RE: Notice of Violation, Town of York – EIS #2018-061-L

## APPLICATION FOR A COASTAL SAND DUNE PERMIT

Dune Permit Application  
Long Beach Avenue  
Seawall Modification  
Town of York, ME

**CONCRETE PEDESTAL DETAIL**

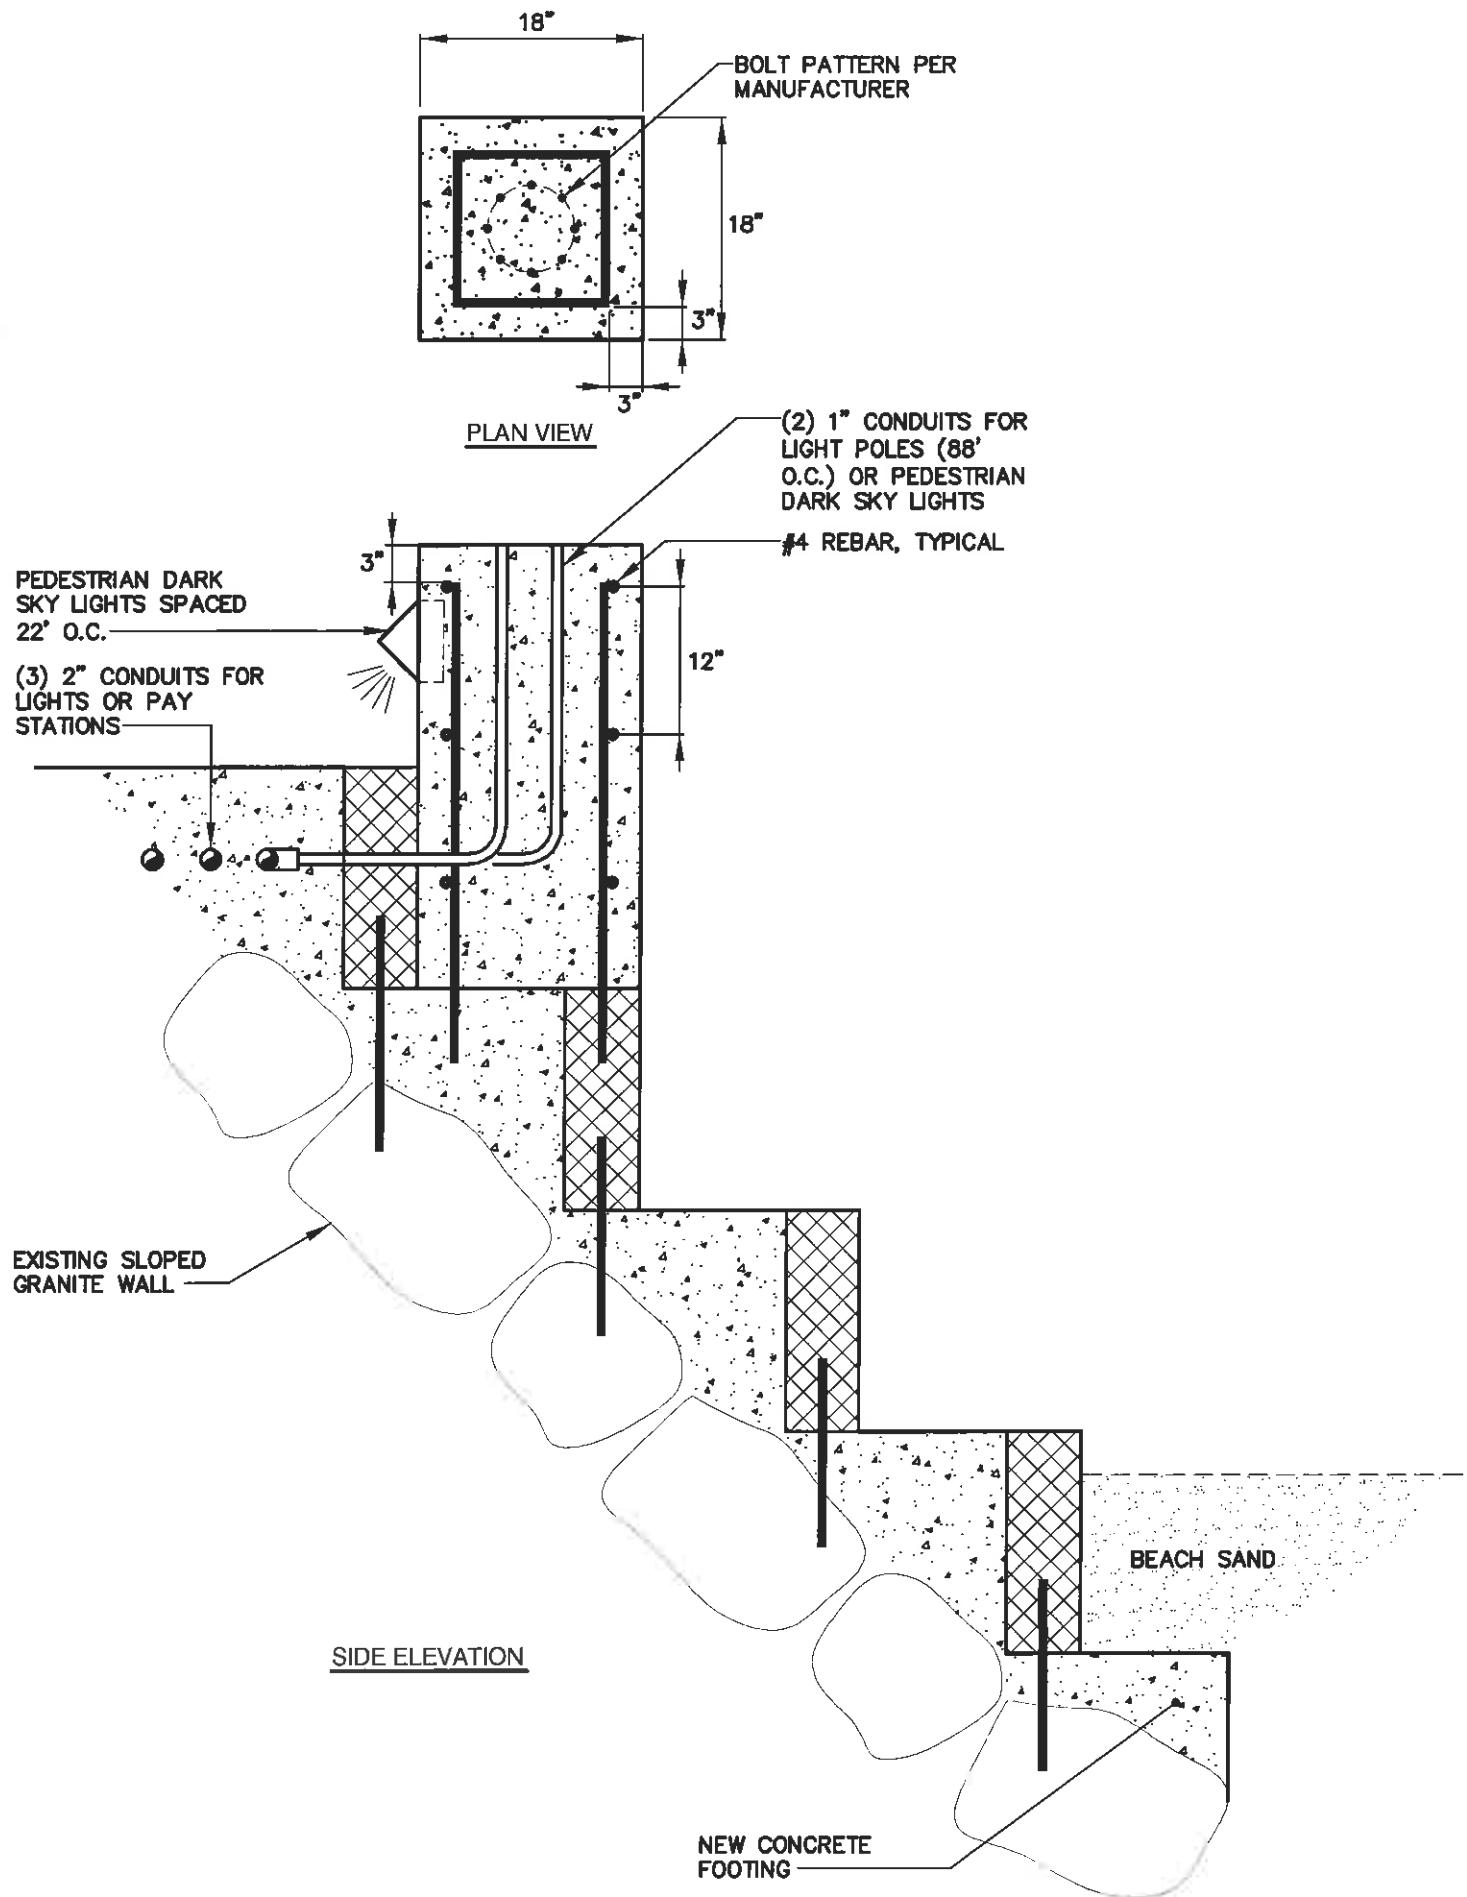
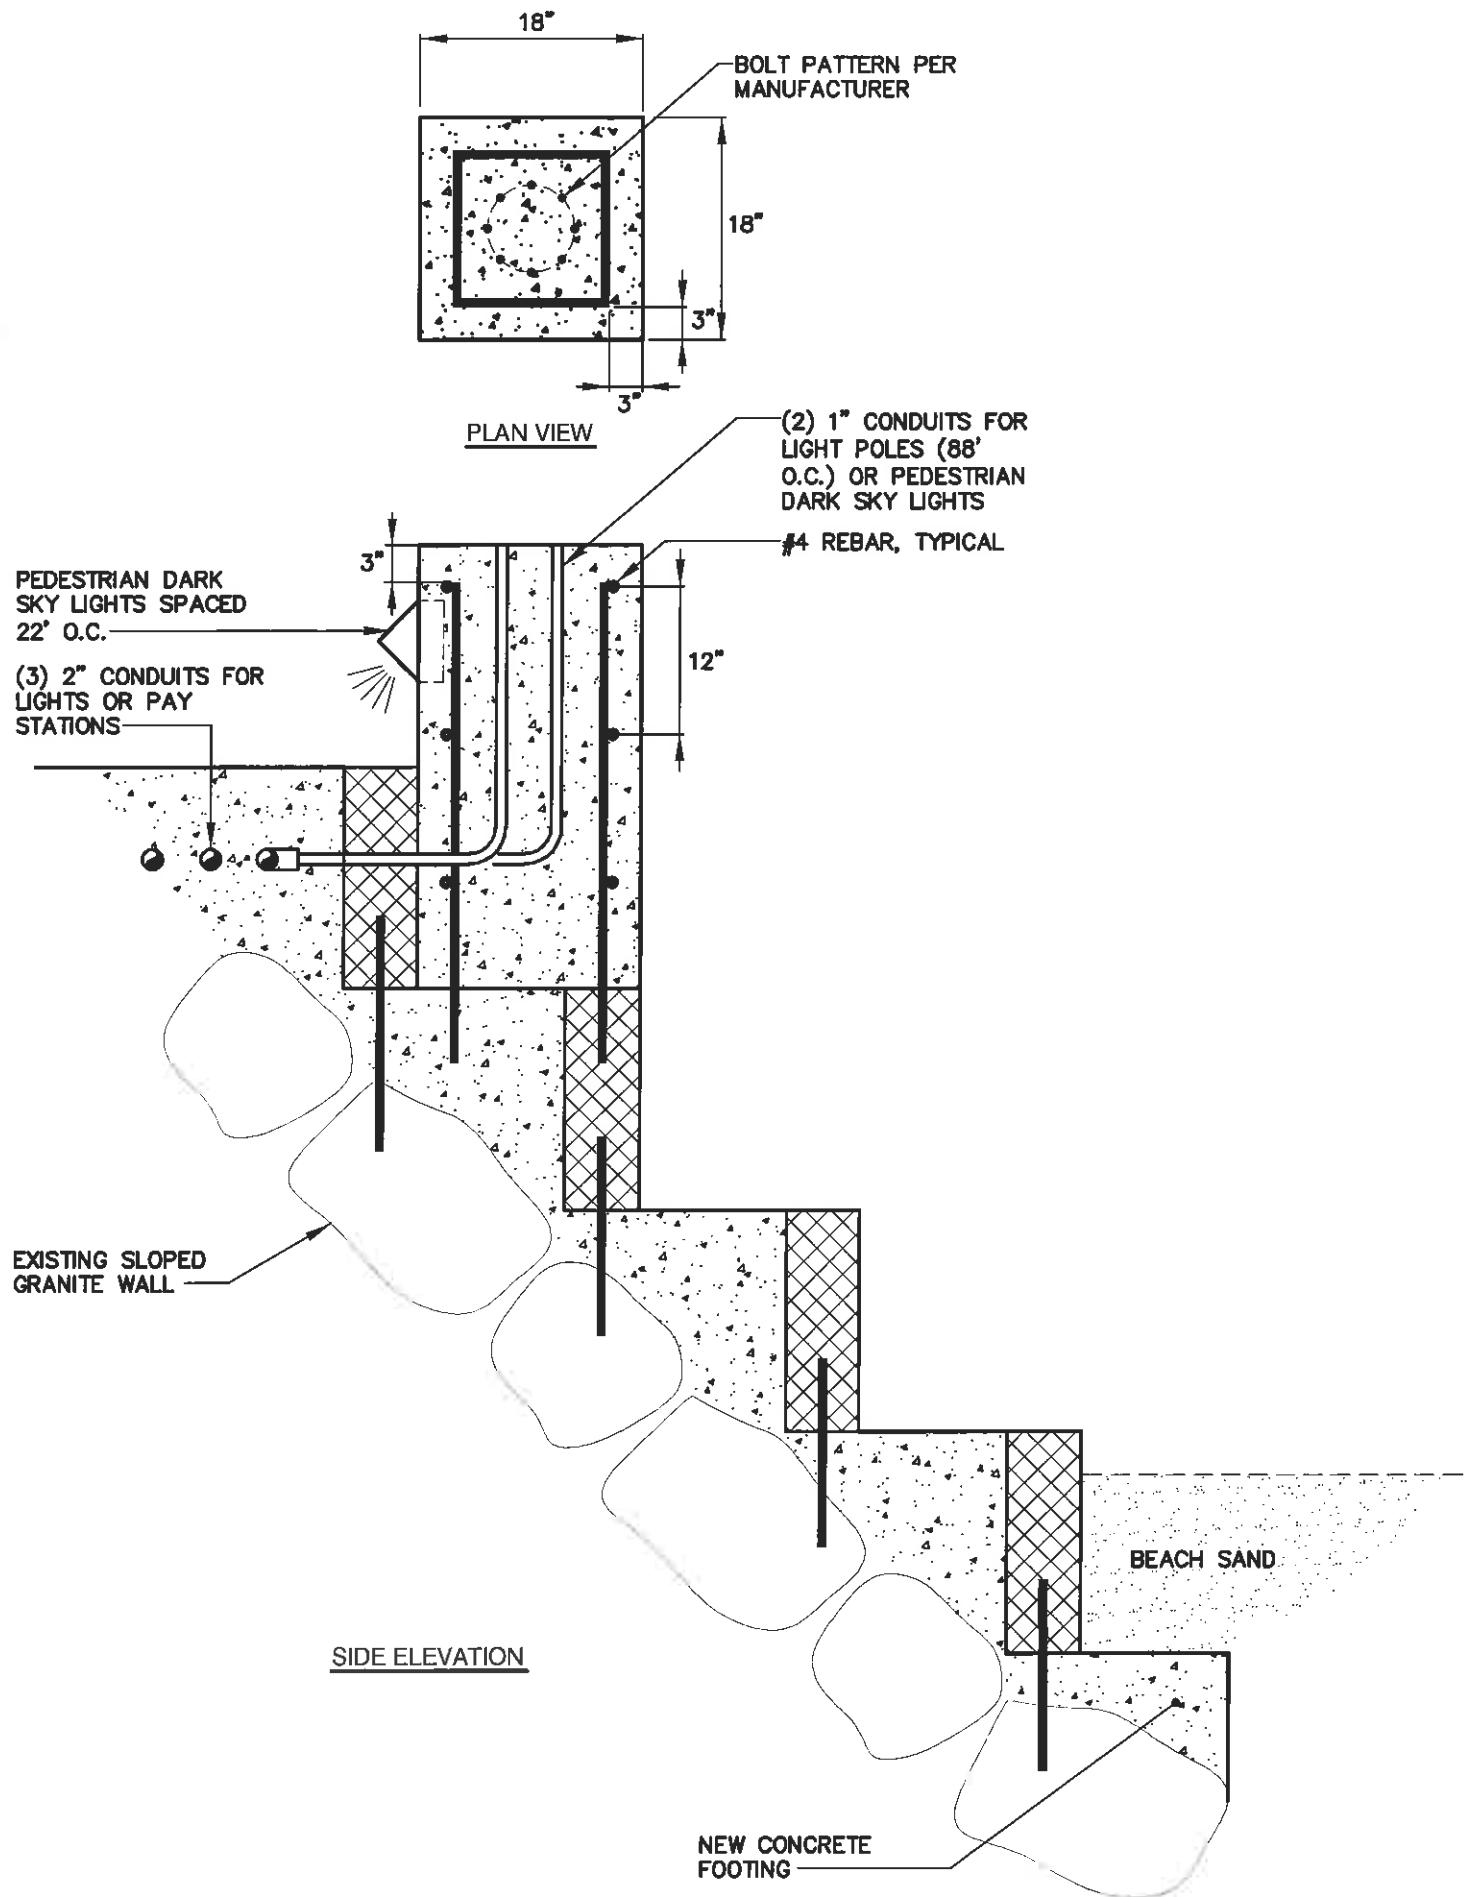
I asked for these plans so that I could make a judgement about the design's conformance with the coastal sand dune rules before work on the stepping began. The only final decision we came to on site was that the ongoing replacement of the footing was ok under the maintenance and repair exemption, since there was no change in dimensions proposed. The stepping plan you described was also not supposed to change the dimensions of the wall in any direction (including "height, length, or thickness" as described in the rules). My goal in reviewing the plans was to ensure the design and your description were consistent in meeting this condition. Seeing the design and the work that has taken place thus far, I have concerns that this requirement has not been met. However, I am going to leave that decision to my supervisors. I will be sending them this information and will be in touch with their response.

I met with my supervisors this morning to discuss your design for updates to the seawall on Long Sands Beach. They determined that the ongoing alteration to the wall does indeed change the dimensions of the structure and will therefore require a sand dune permit. Part of the requirement for alterations to a seawall is that the new design be less damaging to the dune system, wildlife habitats, and any adjacent properties. Typically that is where we loop in our geologists at the Maine Geological Survey to comment on the project.

“height, length, or thickness” as described in the rules). My goal in reviewing the plans was to ensure the design and your description were consistent in meeting this condition. Seeing the design and the work that has taken place thus far, I have concerns that this requirement has not been met. However, I am going to leave that decision to my supervisors. I will be sending them this information and will be in touch with their response.

As we discussed, the seawall footprint could not be expanded but we could change the face to vertical steps rather than the sloped face. The attachment also provides details of the new seawall construction. There is a plan view, a cross section and then a specific detail of anchoring the granite face into the sloped granite seawall.
